A New Fire Station for
Harmonville Fire Company – Plymouth Valley Station

DOCUMENT 00 9001 - ADDENDUM NUMBER 2 – 3/28/25

S3.01

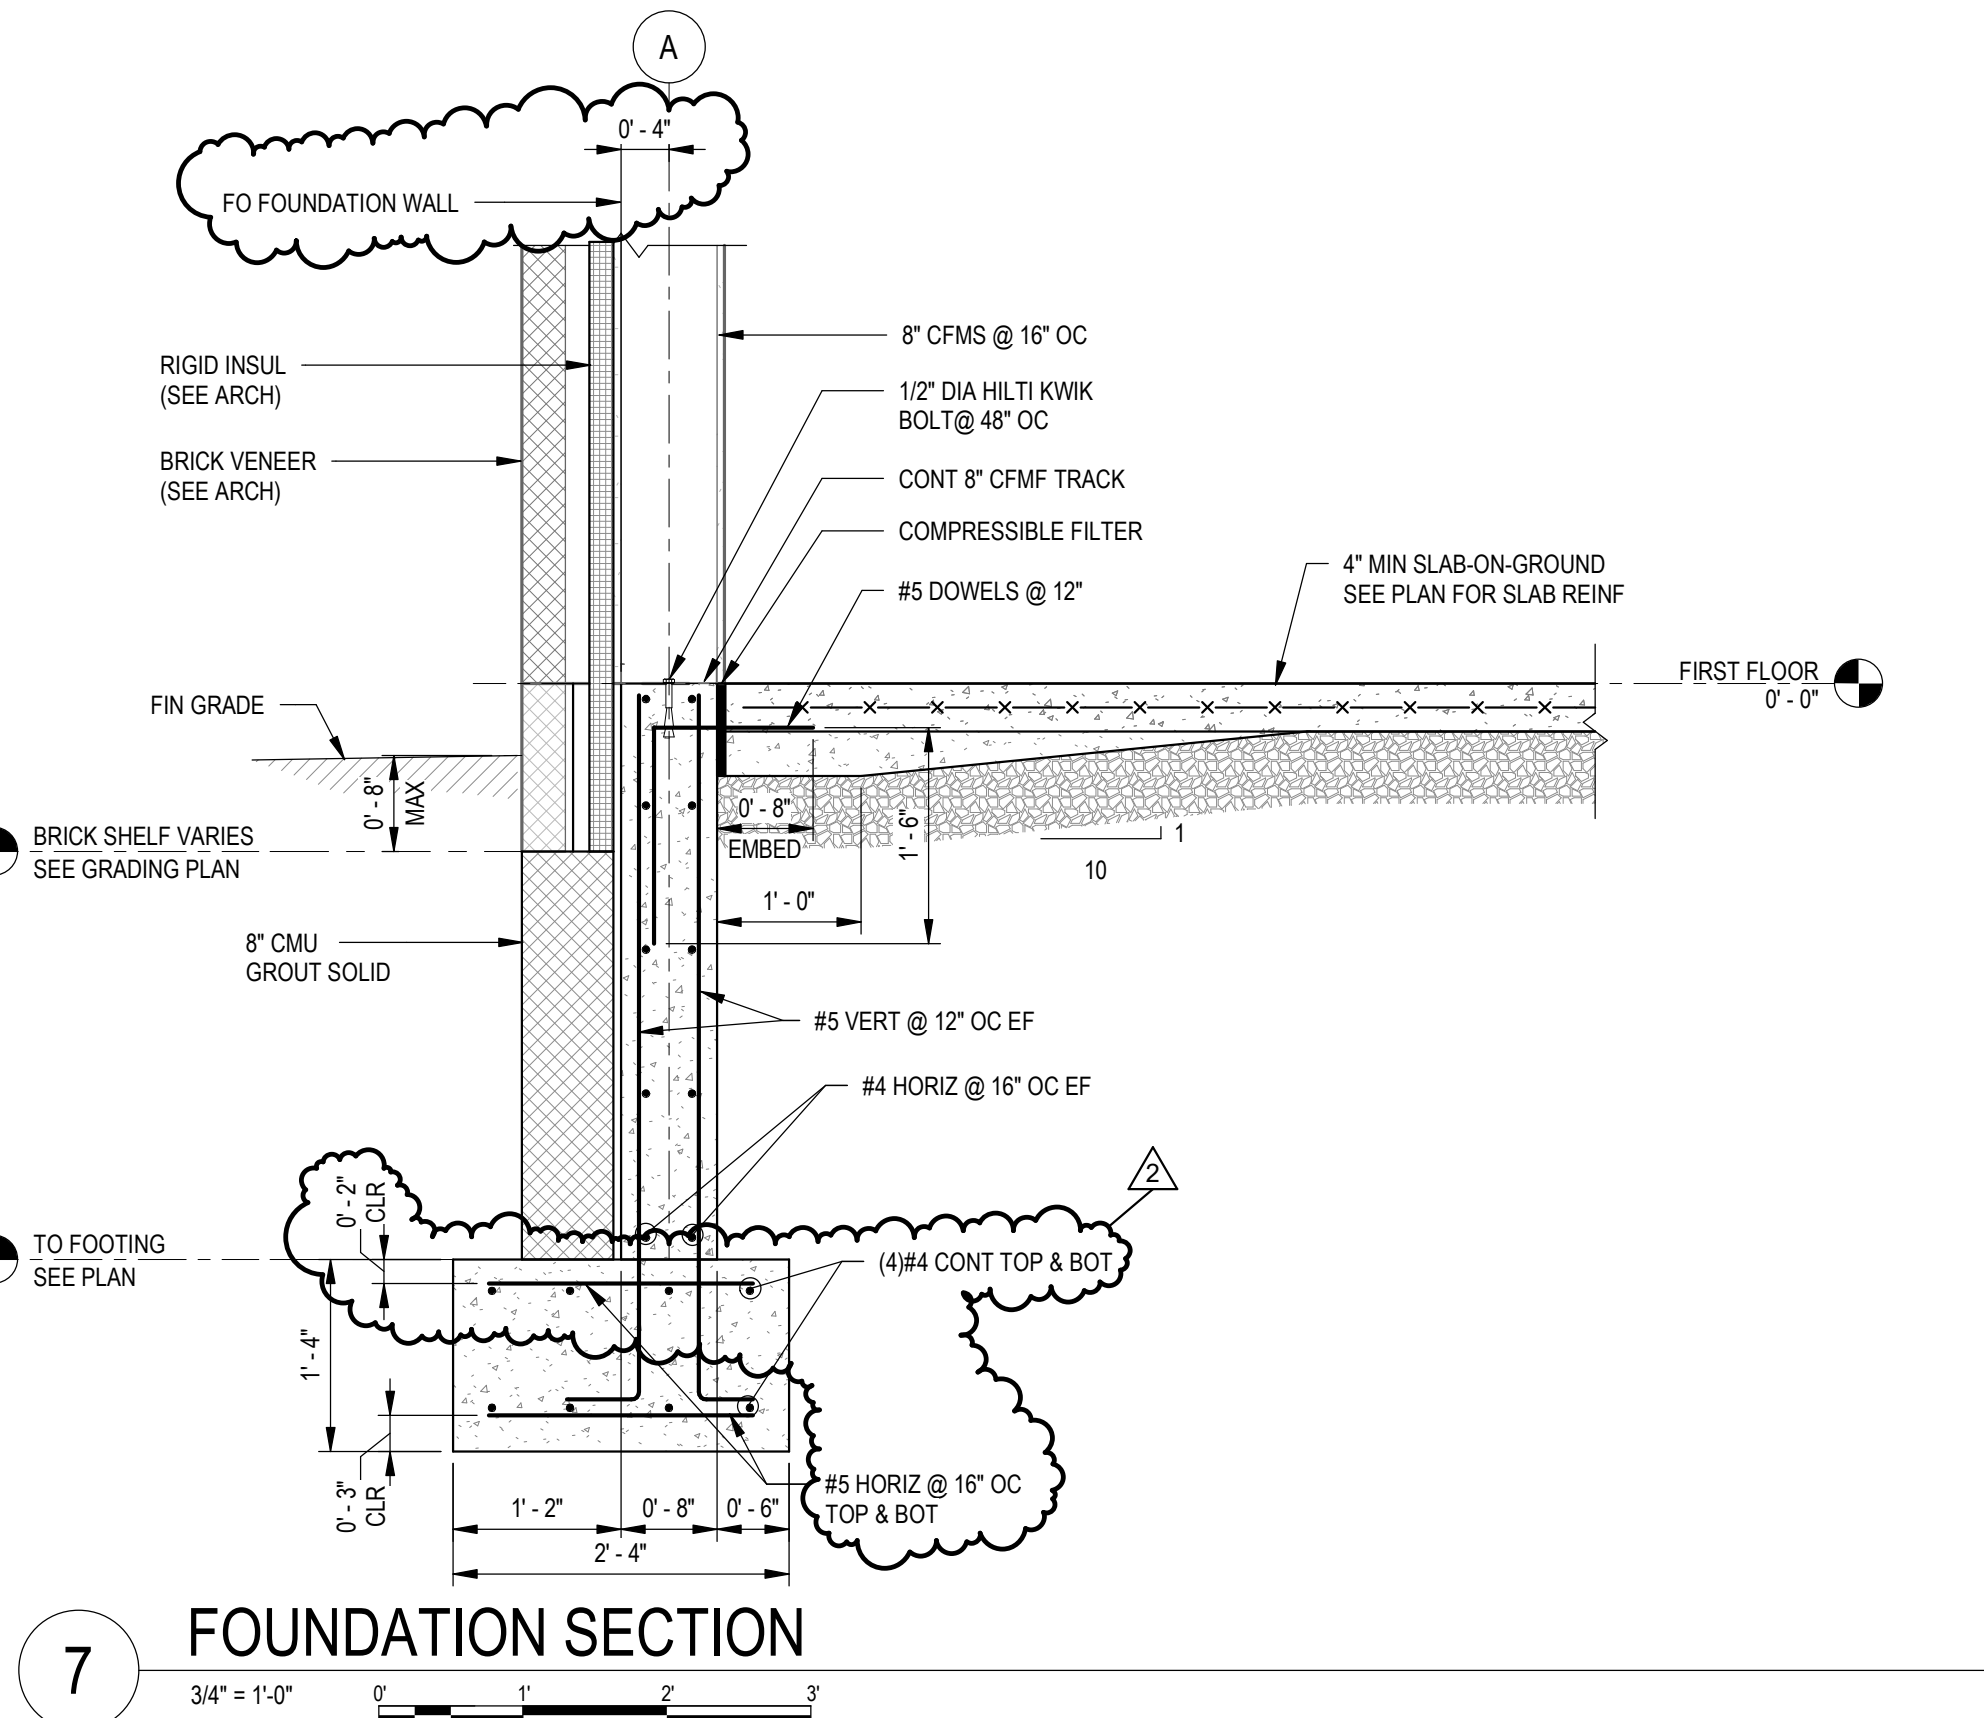
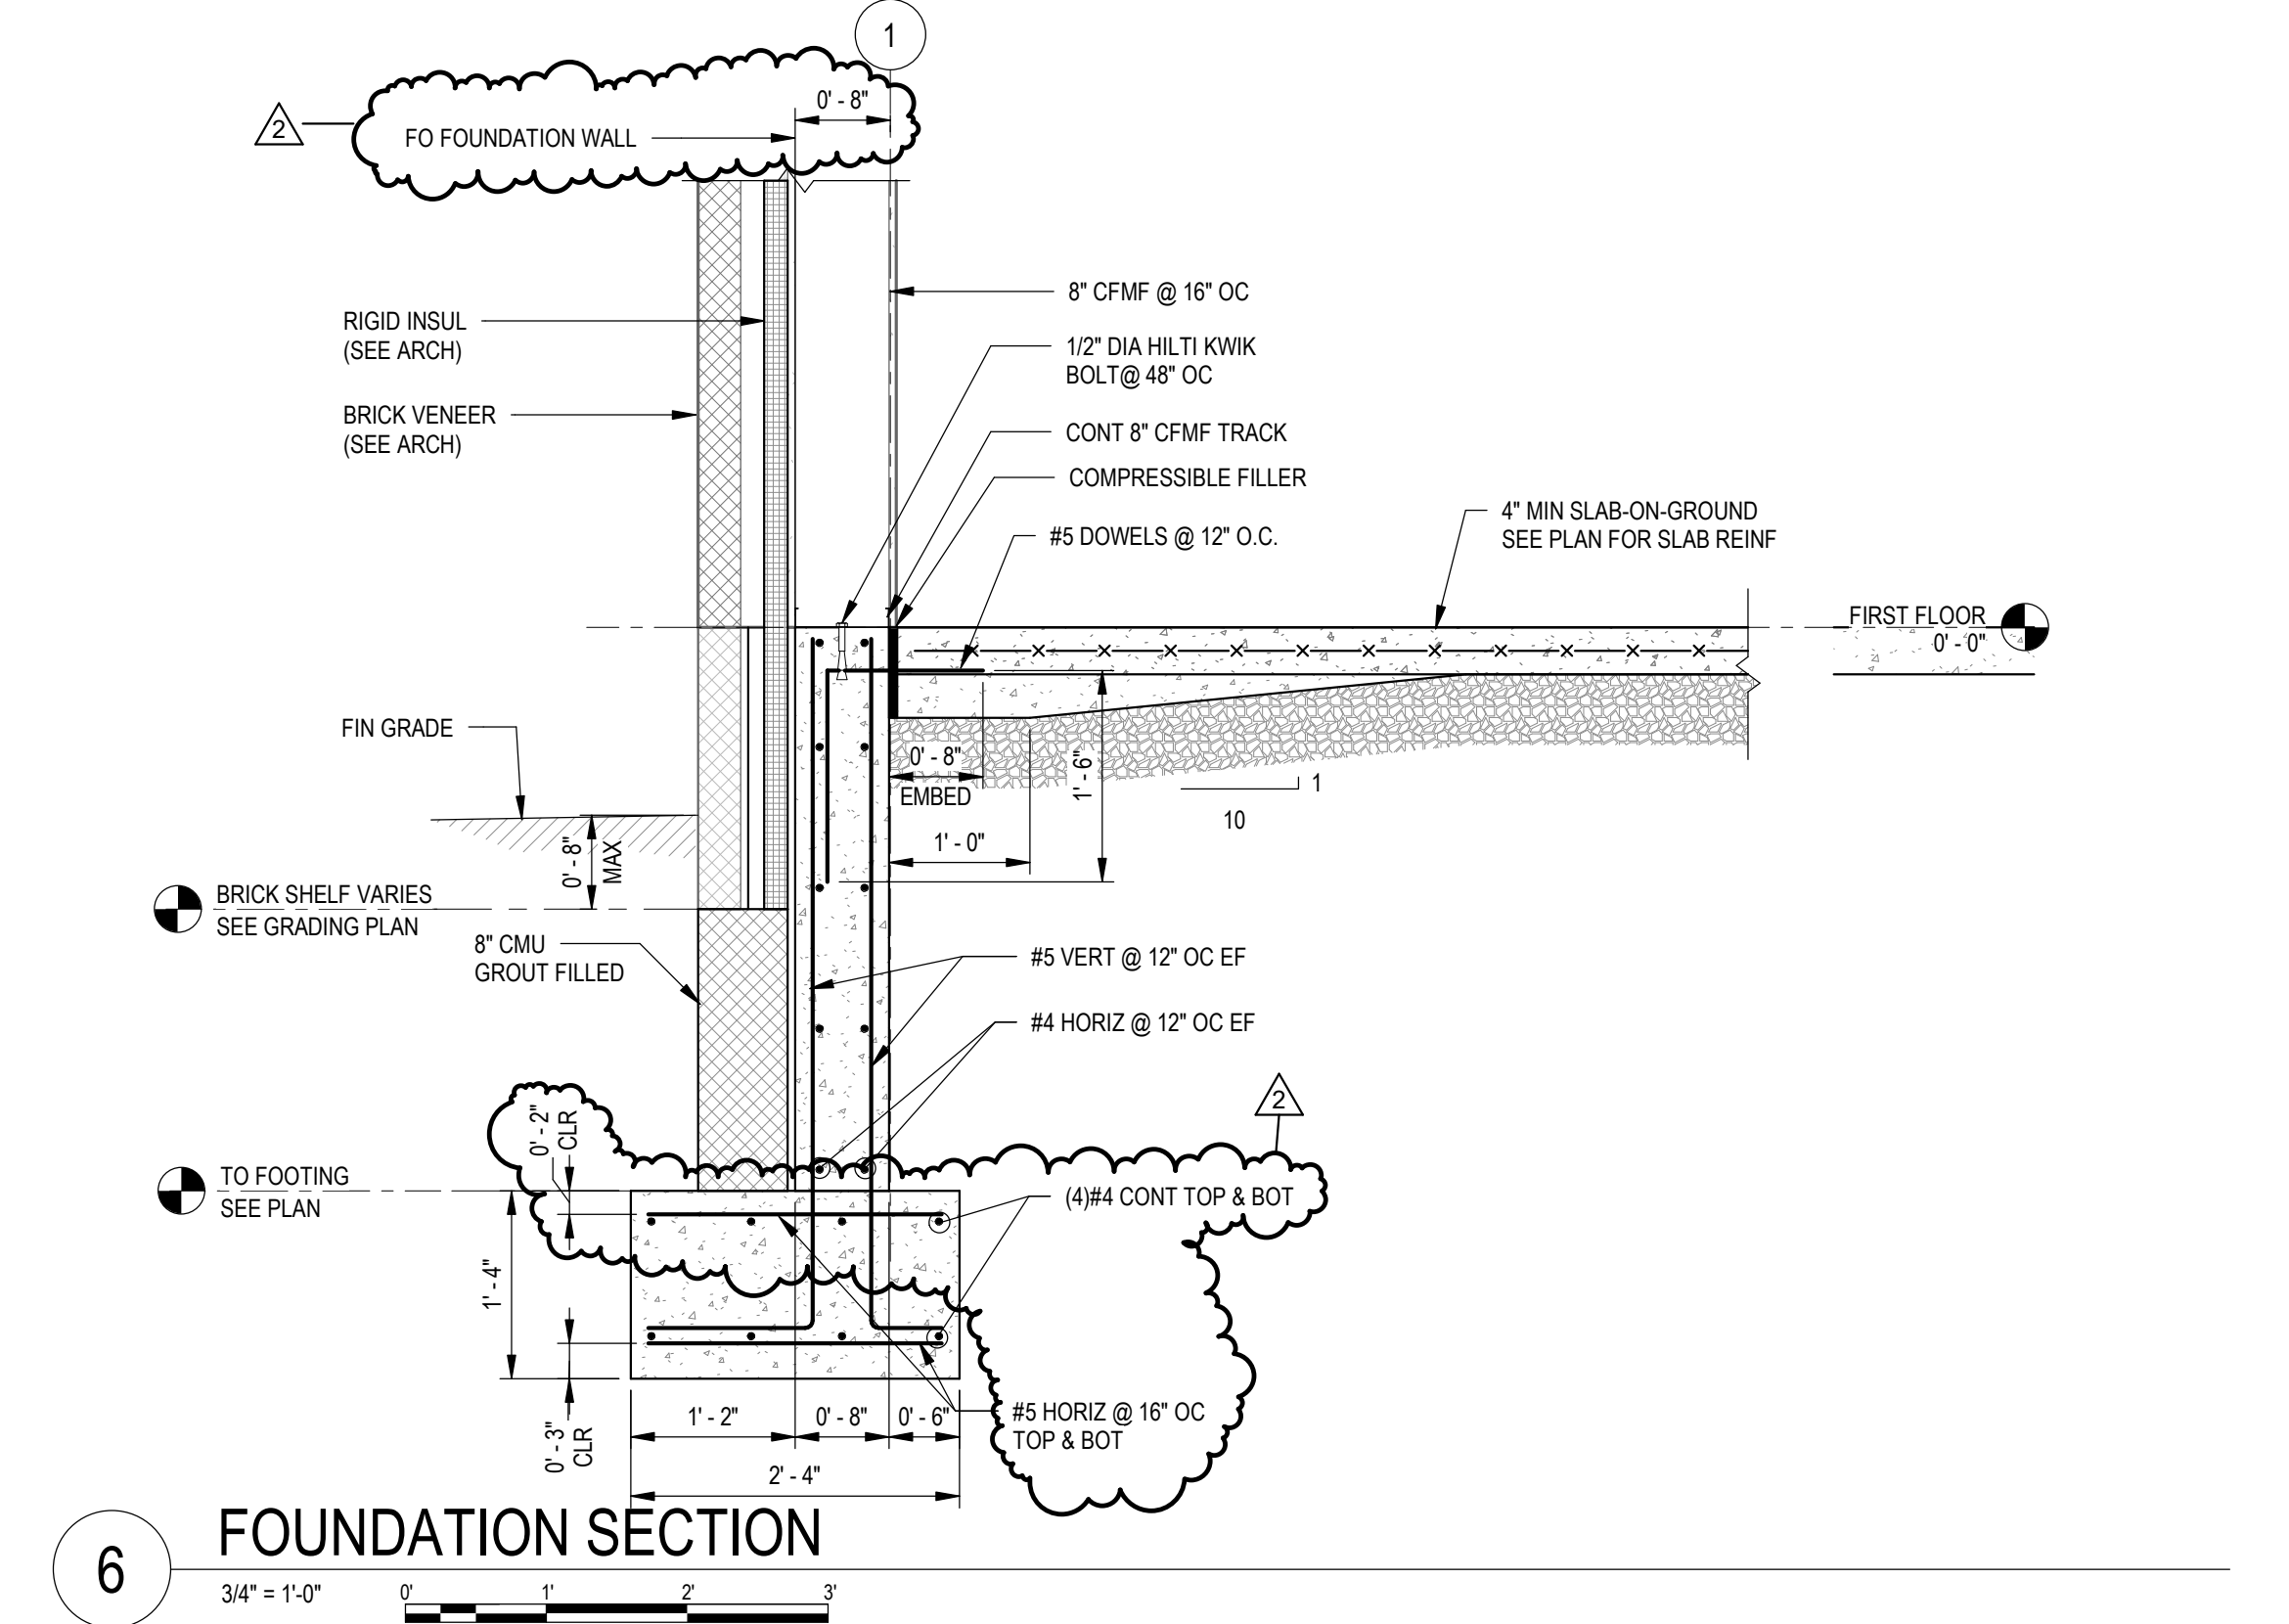
- 9001.20 Drawing sheet S3.01 foundation details have been updated to coordinate with the drawings.
